LANDMARKS BOARD

AGENDA FOR REGULAR MEETING

January 26, 2026

Figure 2: Proposed new design featuring exterior staircase and large shed dormer.

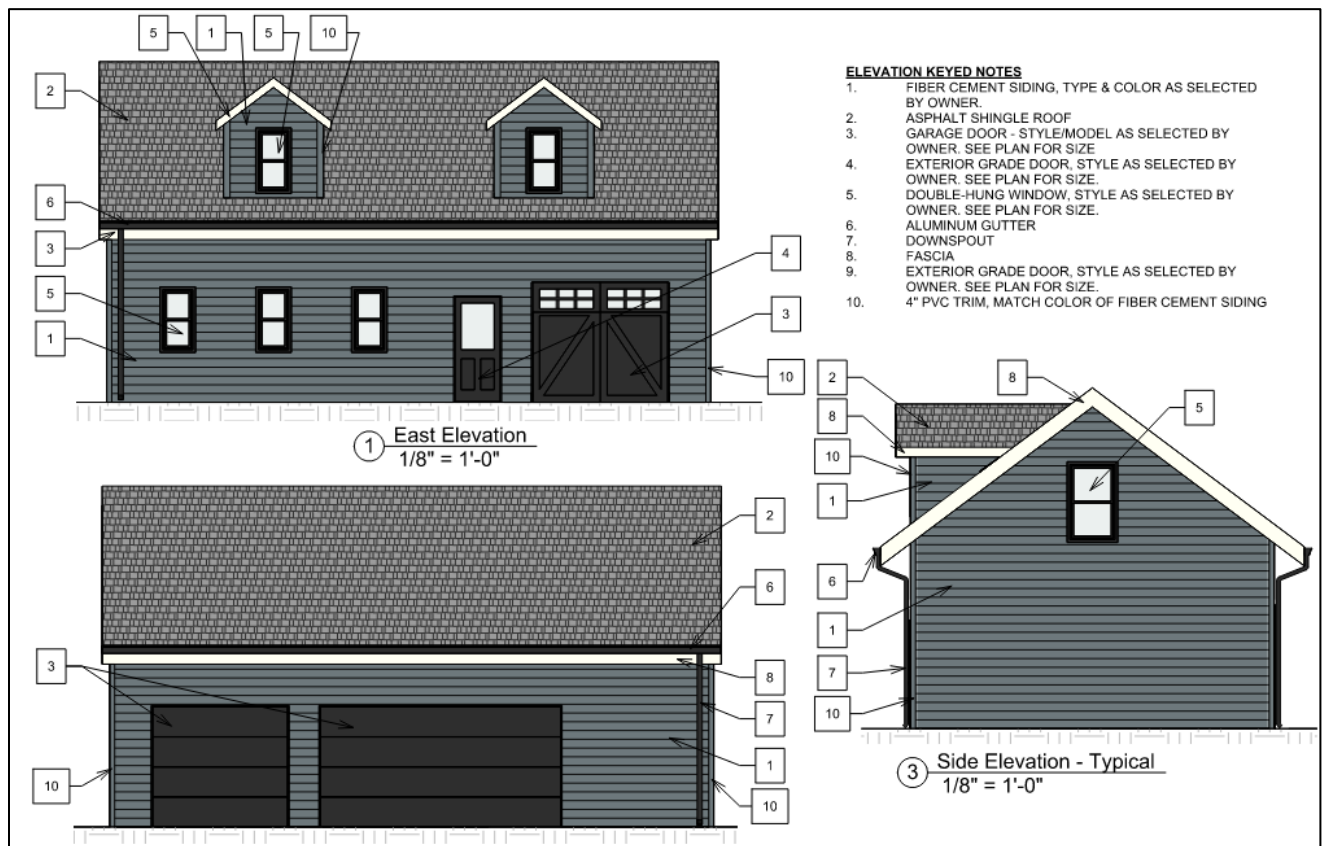
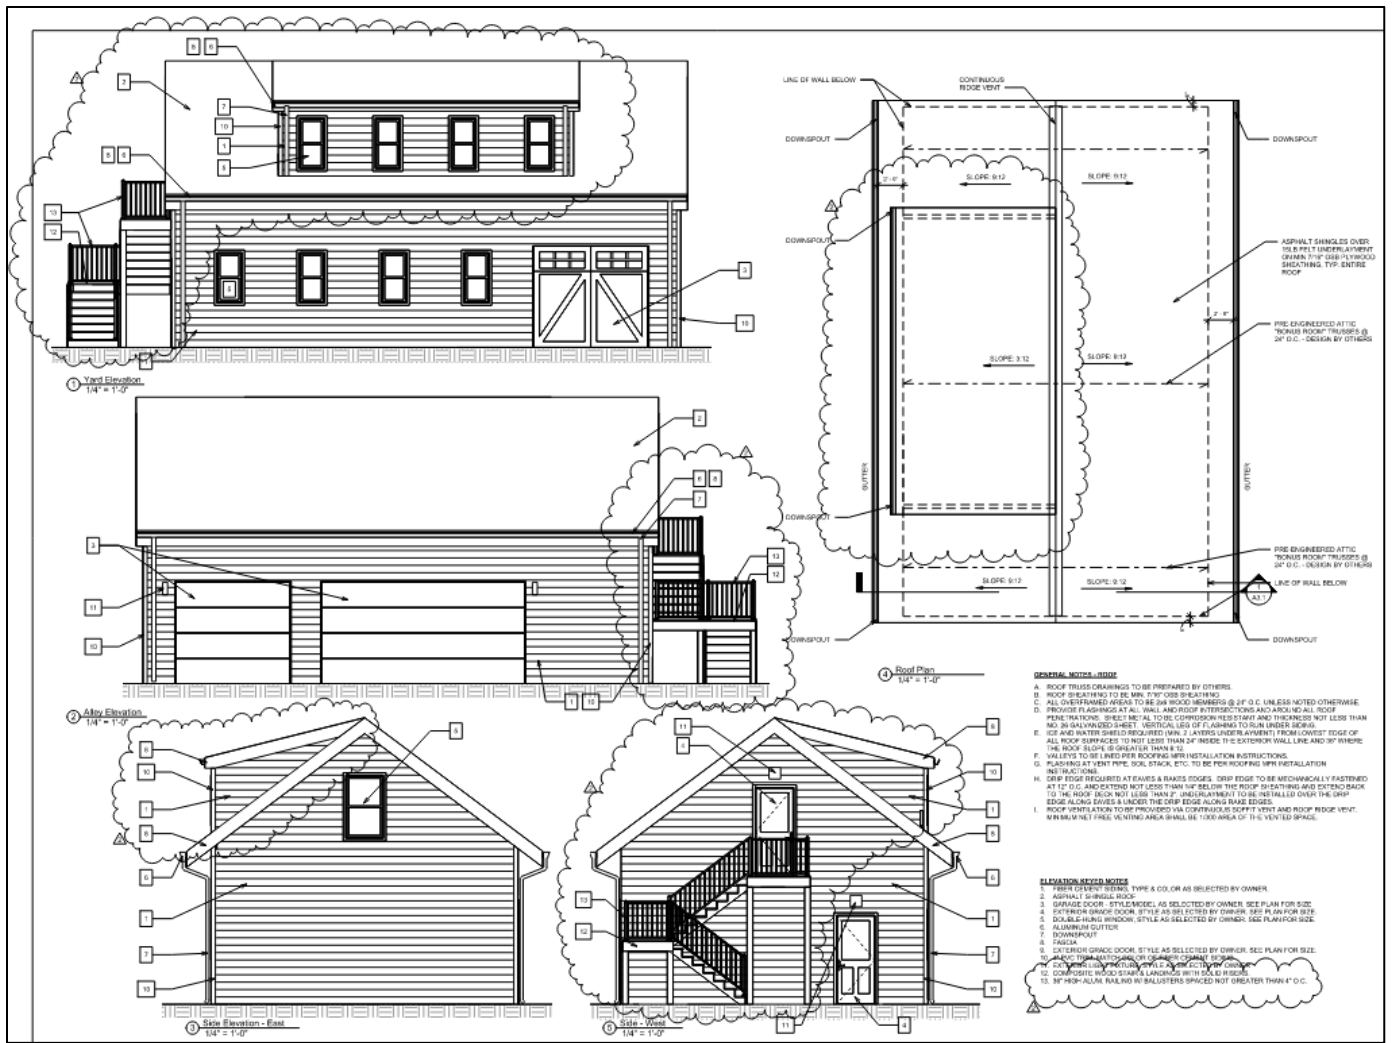
On July 15, 2024, the Landmarks Board reviewed and approved an application to construct a new 1½-story garage in the rear at the above address. The applicant has since submitted revised drawings with their building permit for the garage that require additional review from the Board. The alterations include relocating the steps to the second floor to the exterior of the structure and changing the two (2) gable end dormers into one larger shed roof style dormer to make the upstairs space more functional. The original staff report is attached to this memo for reference.

While the applicant has not indicate a change in use, the introduction of a dedicated exterior stair raises concerns that the second floor may be intended for use as a dwelling unit. In accordance with [Section 400.530\(A\)\(1\)](#), no accessory structure shall be used for a dwelling. The City's Building Commissioner, Dale Nicolas, stated that the stairs would only be required to exit directly to the exterior if the second floor met the definition of a dwelling or living space. However, the second floor does not provide complete independent living facilities for one or more persons, including all required permanent provisions for living, sleeping, eating, cooking, and sanitation.

Overall, the changes are compliant with the standards of the district. All materials being utilized are also appropriate for new construction within the area. Therefore, Staff recommends approval of the revised garage design, subject to the following condition:

Sheet Title:
**Rear Deck Framing Plans,
Elevations**

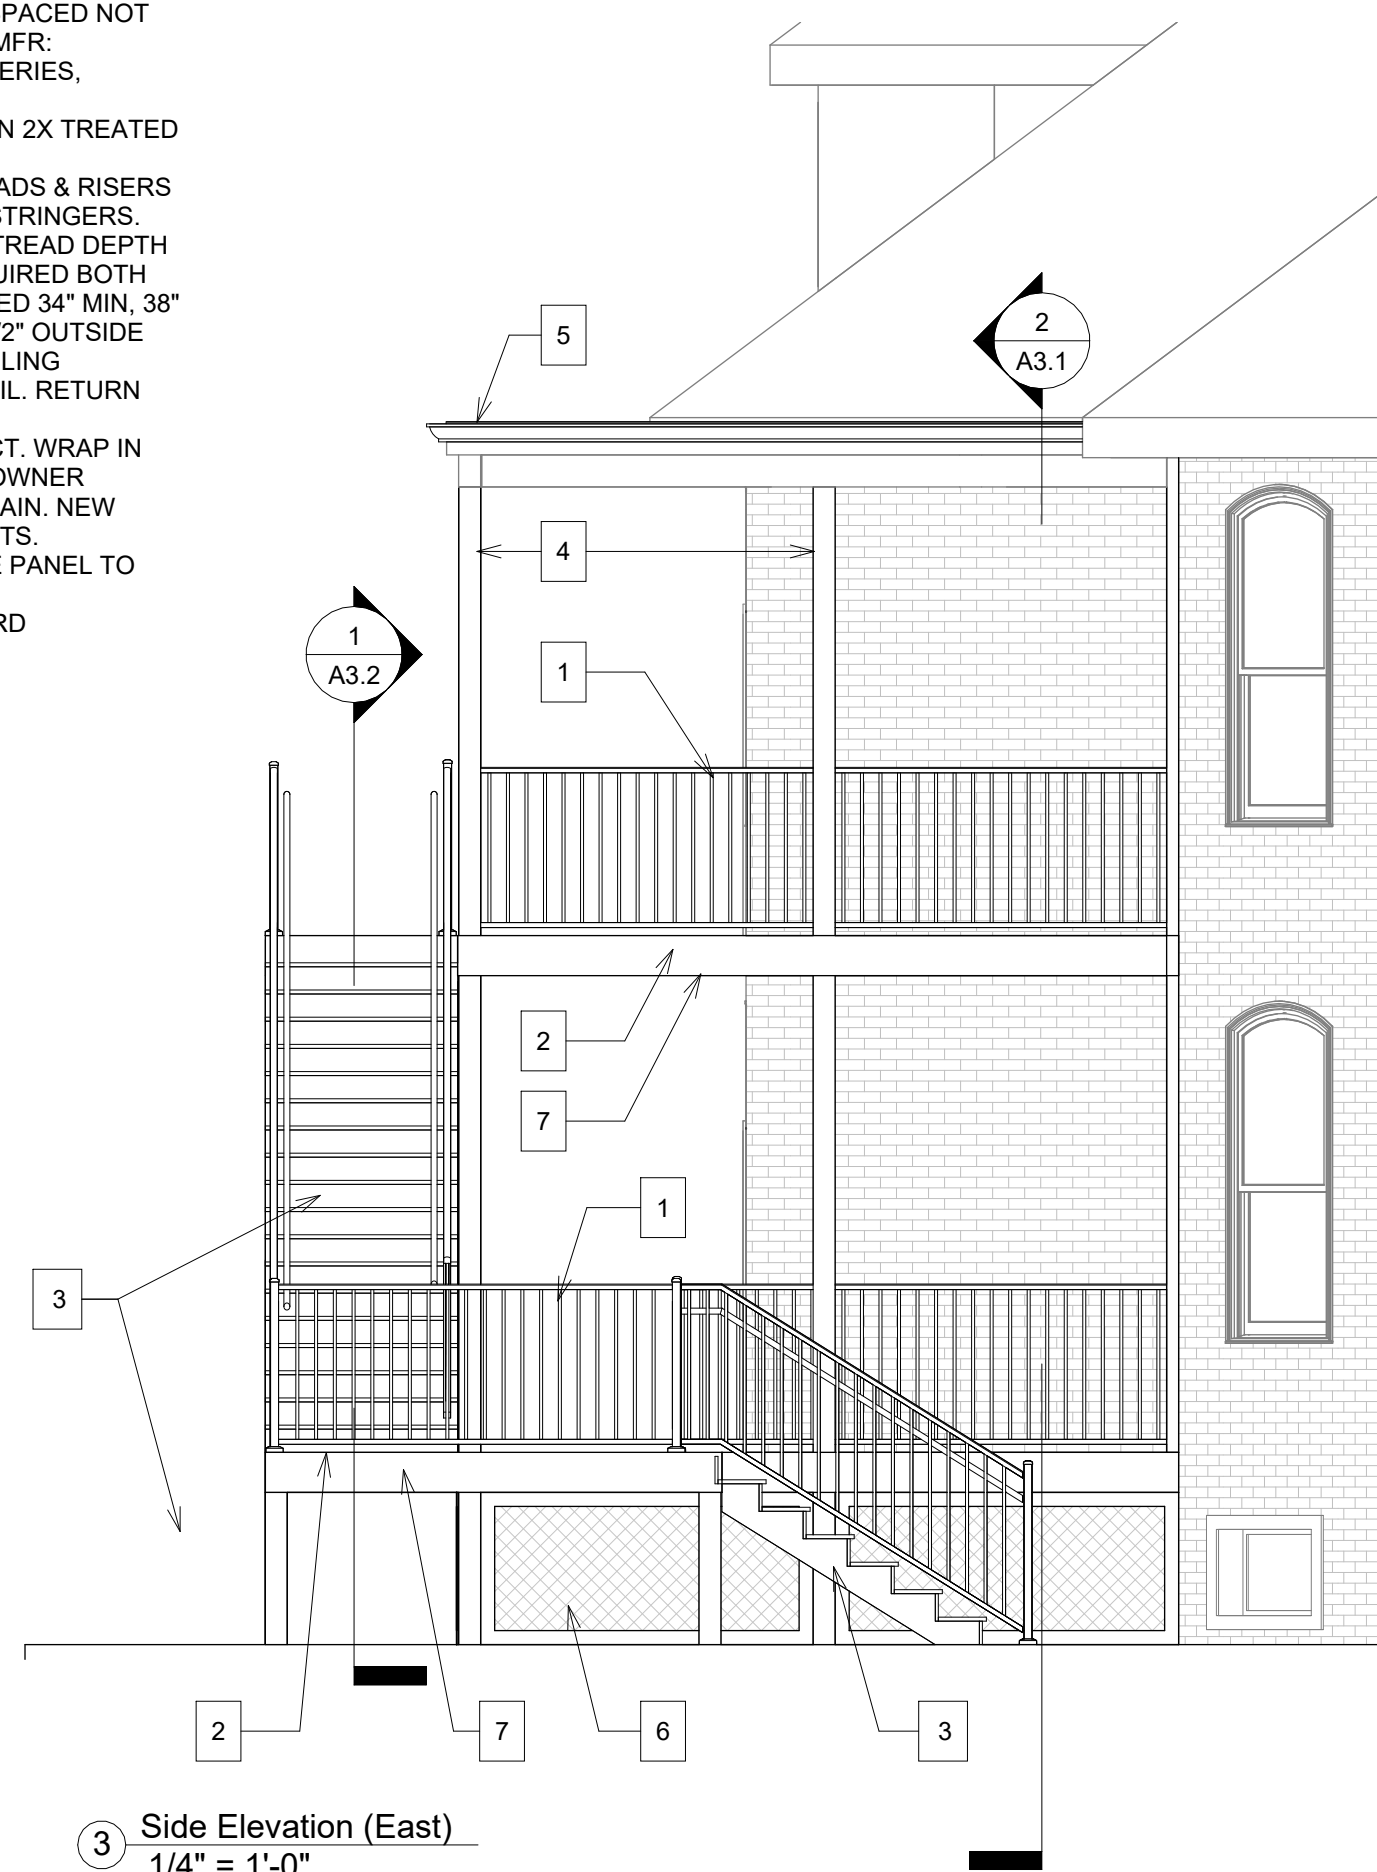
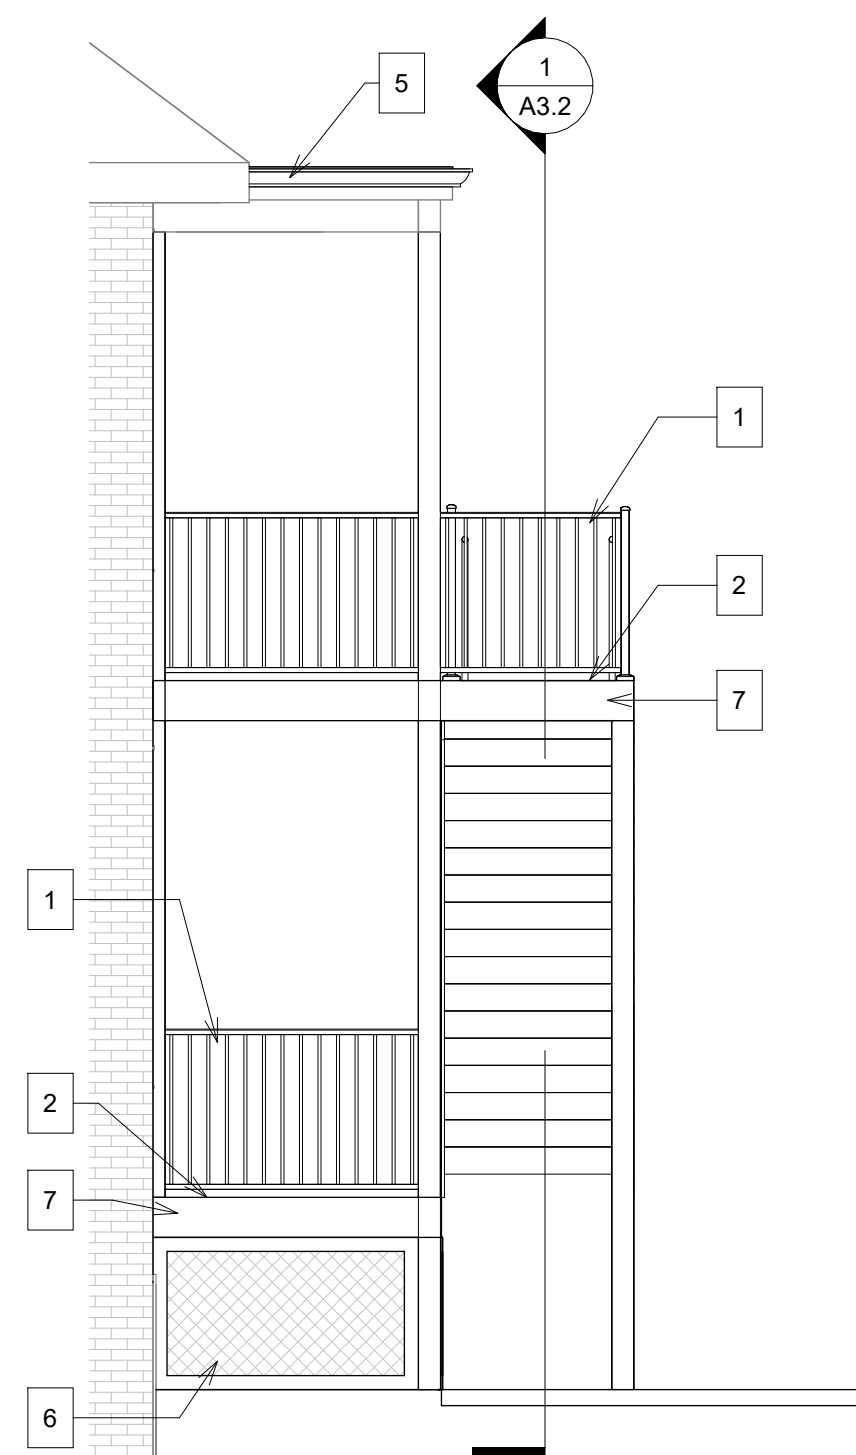
While the proposed black aluminum railing is generally appropriate for the new rear deck, Staff finds that a white railing system may be a more compatible alternative. The previously existing two-tiered deck featured white-painted wood railings, and the use of a white railing system would better reflect that historic appearance. Additionally, a lighter-colored railing would reduce visual heaviness and provide a more subtle, cohesive appearance given the amount of railing proposed.

Figure 3: Proposed site plan for new fence.

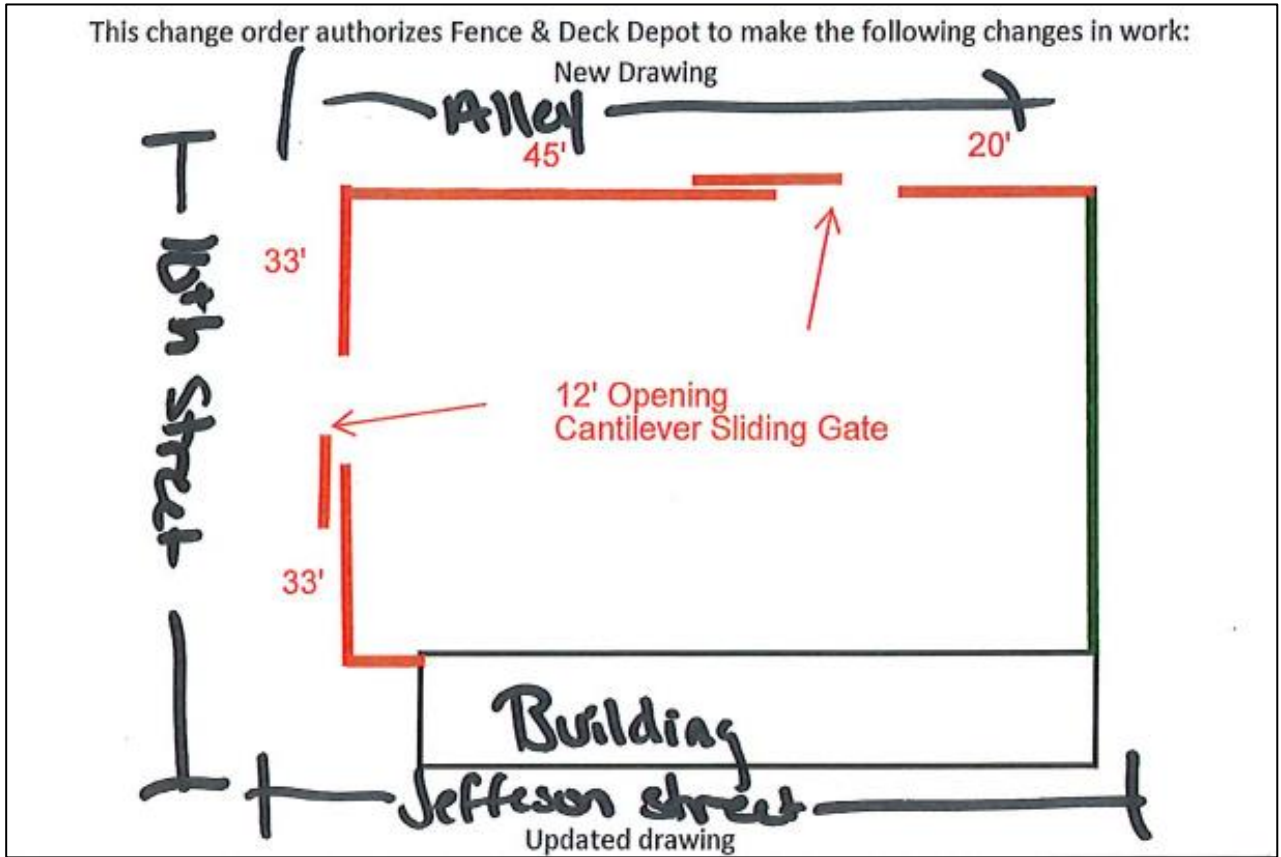
The site plan features two motorized gates, one which leads to 10th Street and one that leads to the rear alleyway. While the proposed fence is located at the intersection of the alley and North 10th Street, the applicable corner visibility requirements pertain to intersections of public streets. Furthermore, the proposed fence height and open material design will maintain adequate sight visibility for vehicles exiting the alley on to 10th Street. Therefore, Staff recommends approval of the new fence, subject to the condition below:
